## **Arlington Zoning Board of Appeals**

**Date:** Tuesday, October 25, 2022

4. Docket # 3715: 39 Woodside Lane (Continuance)

RE: Docket 3715 – 39 Woodside Lane; Special Permit under Zoning Bylaw 5.4.2.B(6) Districts

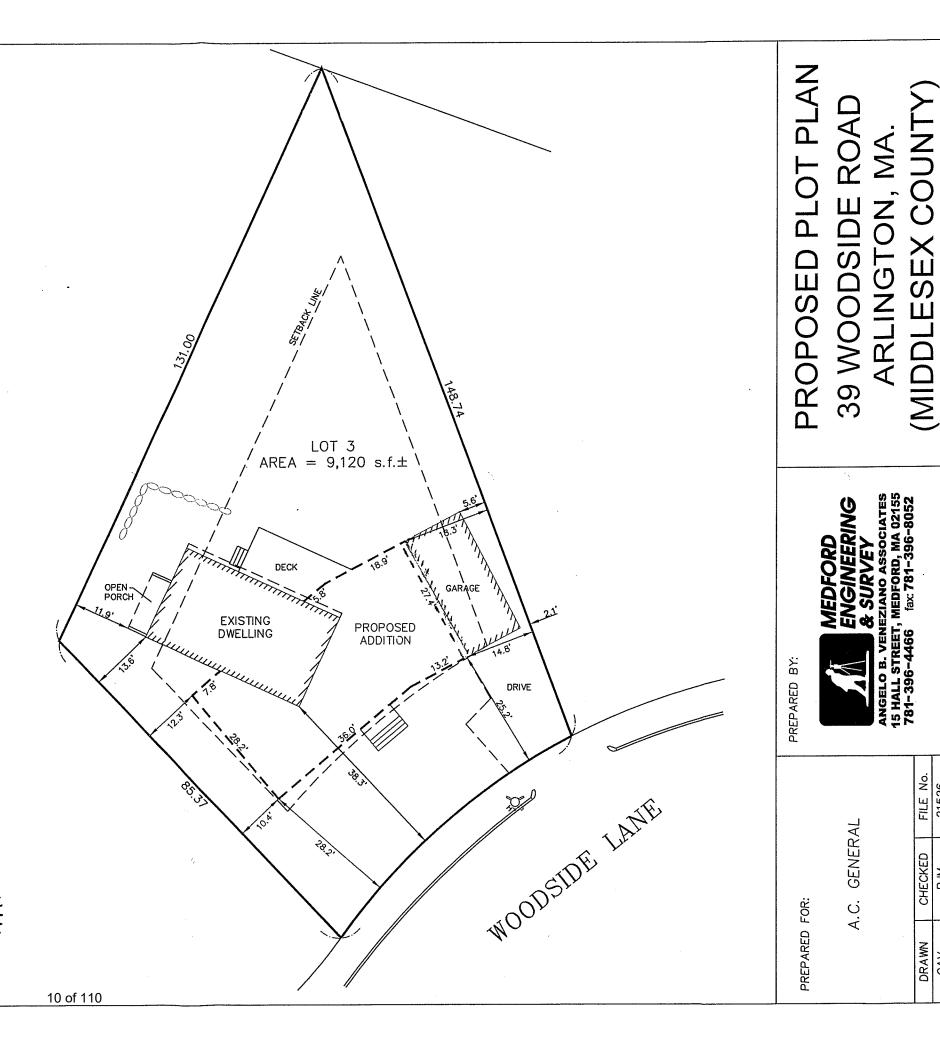
After going back to the site and performing a detailed topo survey of the area between the existing dwelling and the street line at Woodside Lane, we determined that we could not find any area that is at least 20' in all directions with a slope of under 8%, giving a net usable open space area of 0 s.f. and a usable open space % of 0.

I was then asked to use the revised floor plans, showing an additional garage on the right front corner of the addition and connect the existing driveway to the new garage. To do this, I needed to add a retaining wall along the left side of the new edge of driveway, from the new garage to the street line of Woodside Lane. The resulting change in elevations from the top of the wall to the left property line, would yield a net slope of 5.5% and a usable open space area of 1,190 s.f. and a usable open space % of 35.2%.

The wall will need to be designed by a Structural Engineer and approved by the Town of Arlington Engineering Department.

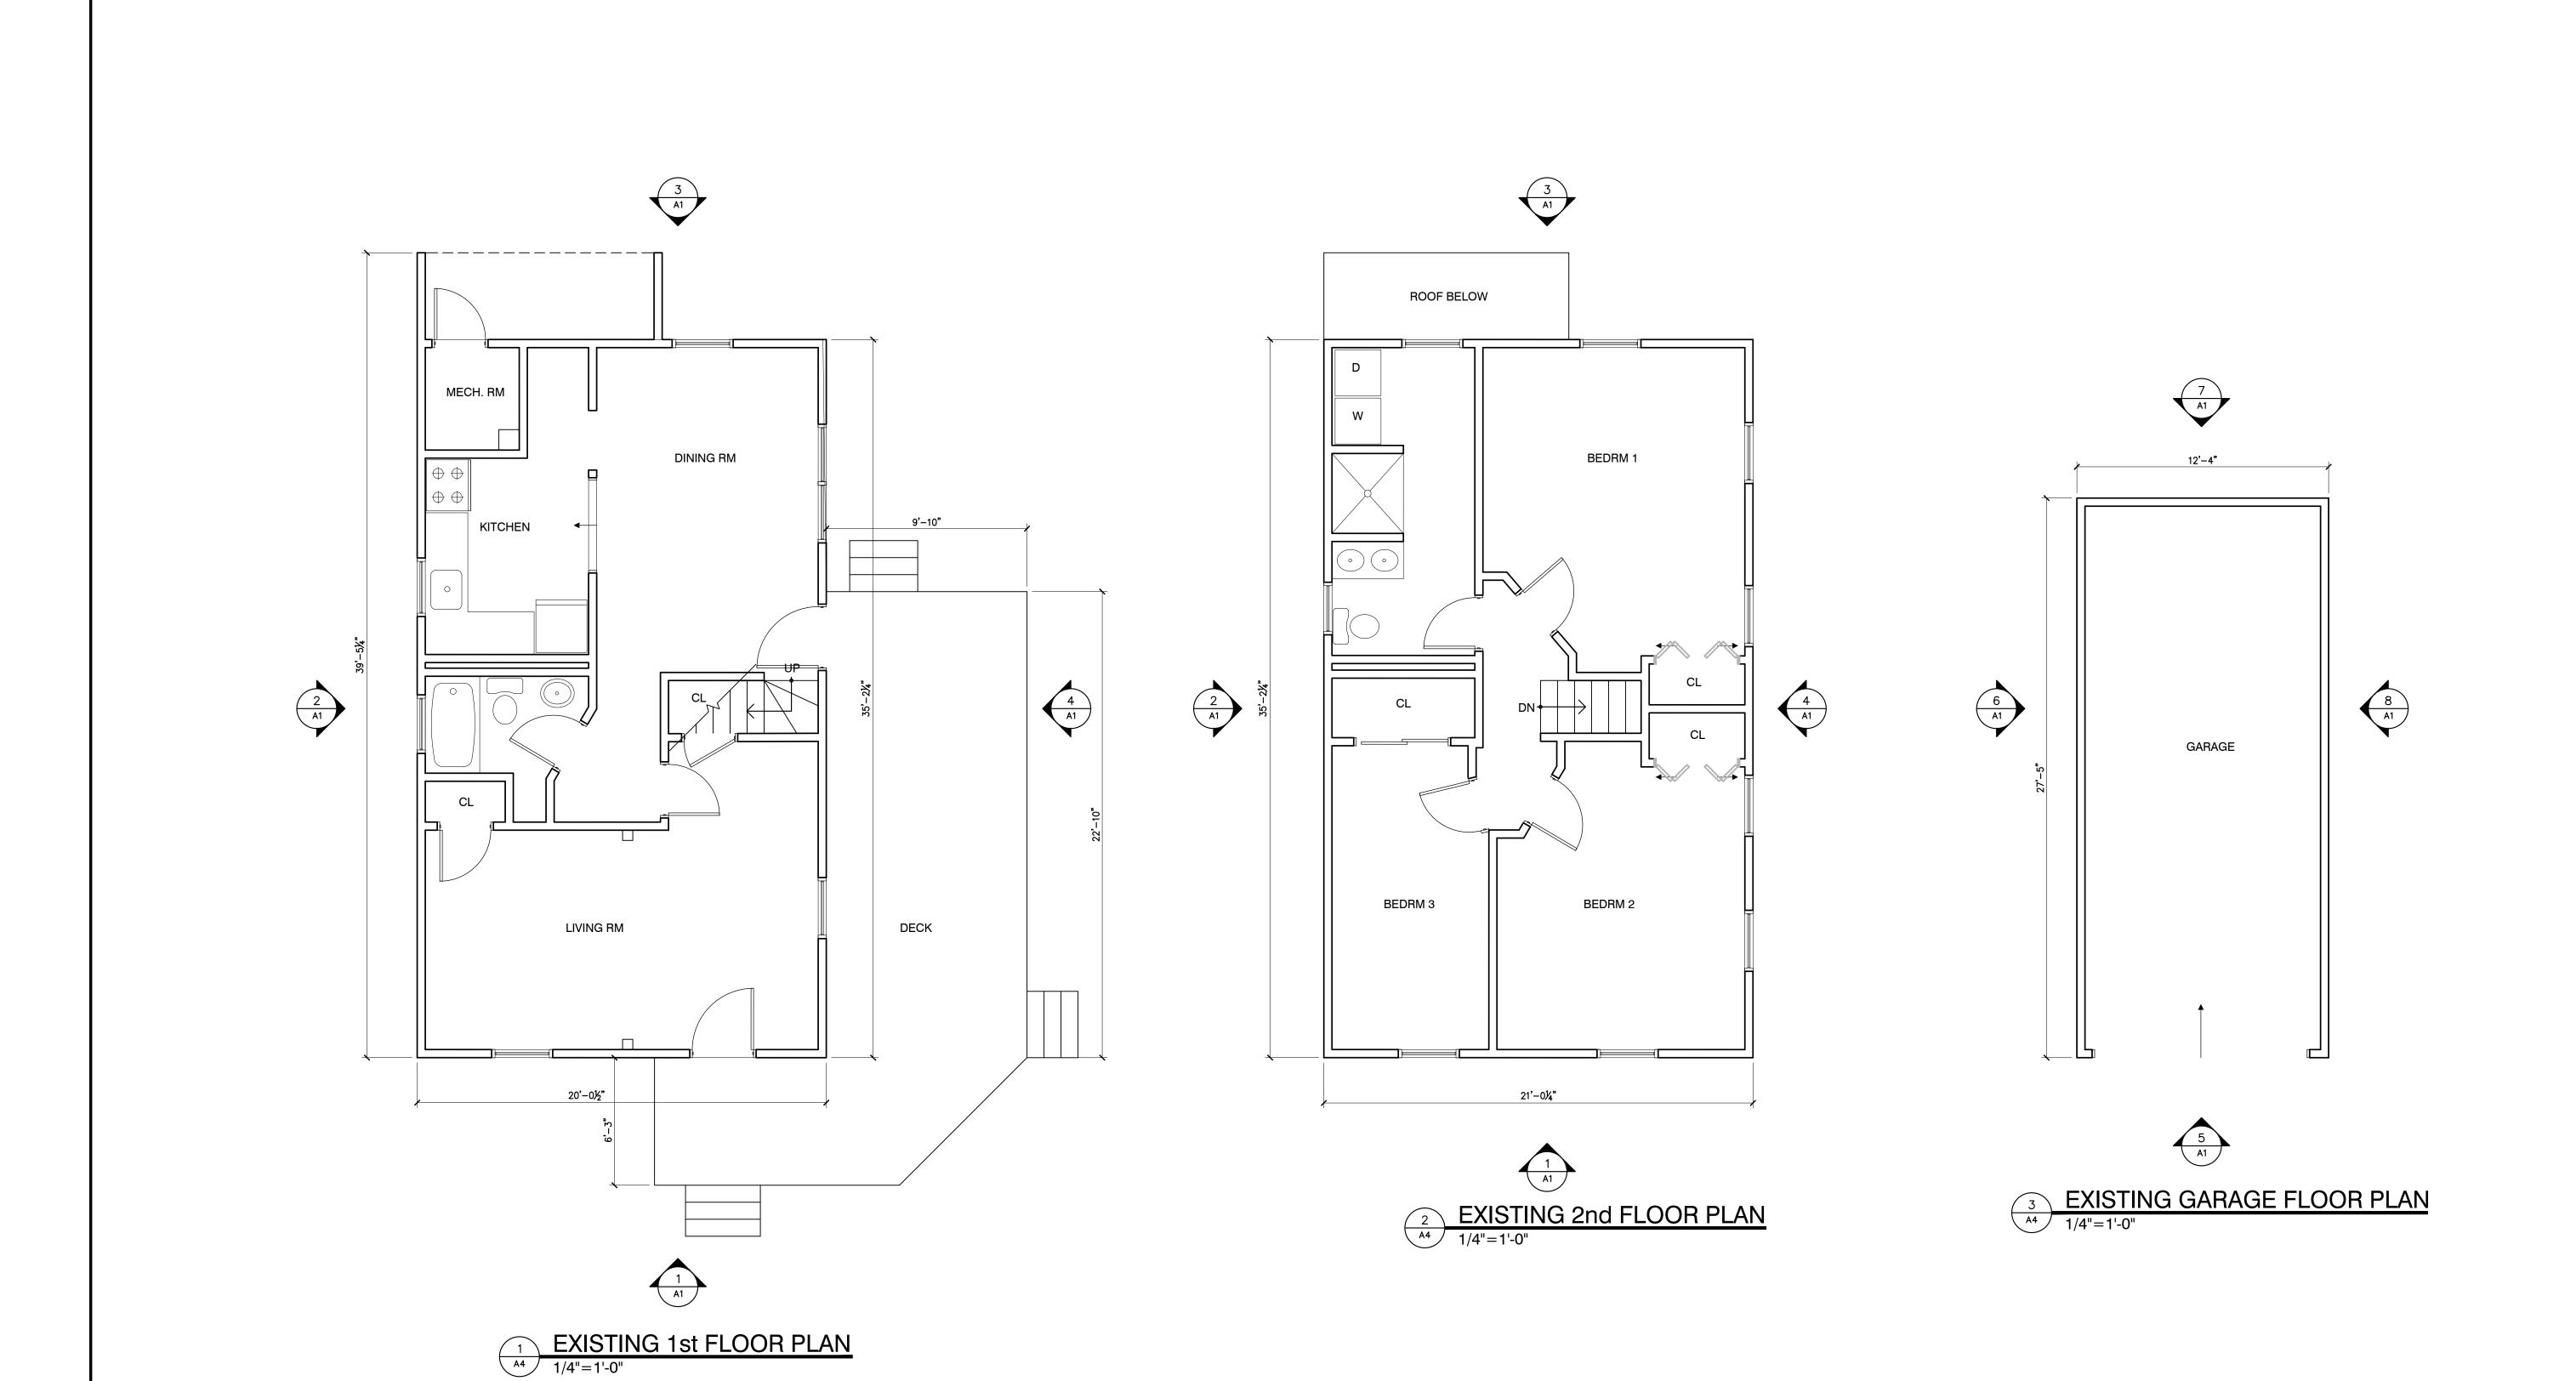
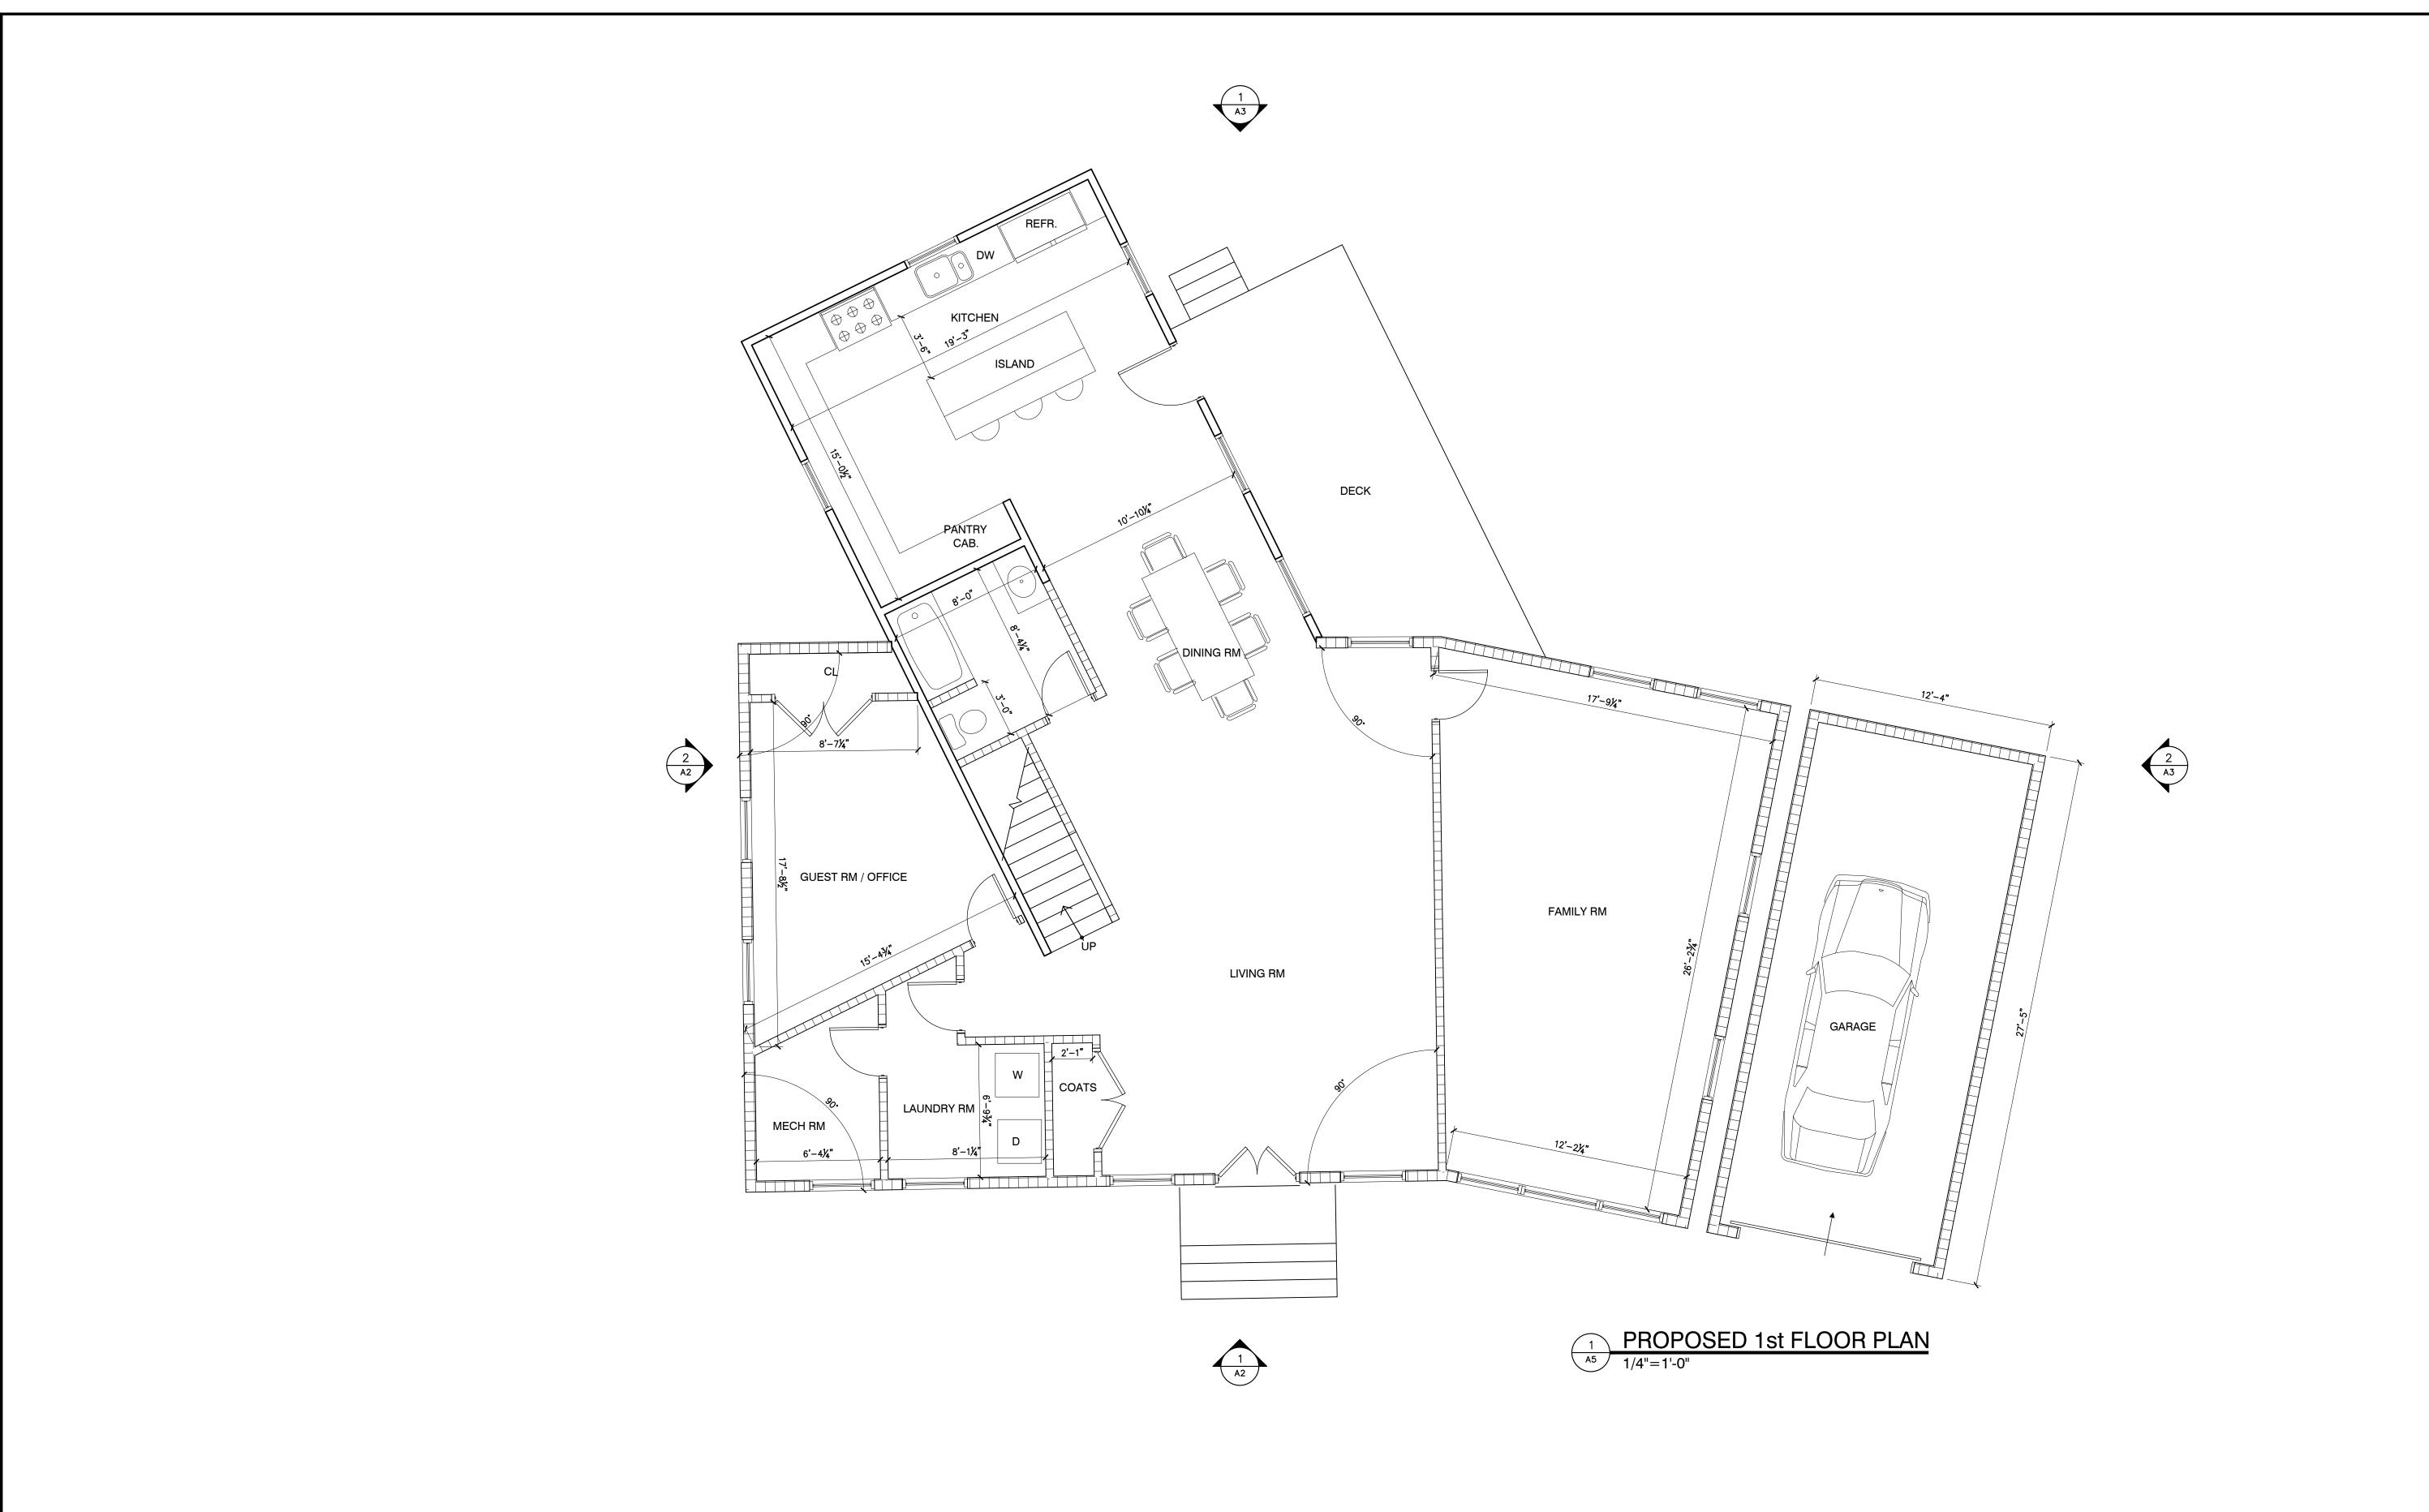
The application states the proposal would increase the gross floor area of the attic to 769 SF (+431 SF). Per the definition of a half story in Section 2 (Definitions) of the Zoning Bylaw, "less than one half of the floor area measured from the underside of the roof framing to the finished floor below has a clear height of 7 feet 0 inches or more." It is unclear based on the materials submitted by the applicant whether a half story is proposed and if so, whether the dimensions of the finished floor area would comply with this definition.

DPCD recommends that the Zoning Board of Appeals (ZBA) requests that the applicant provide attic floor plans to clarify dimensions of the finished floor area and side elevations.
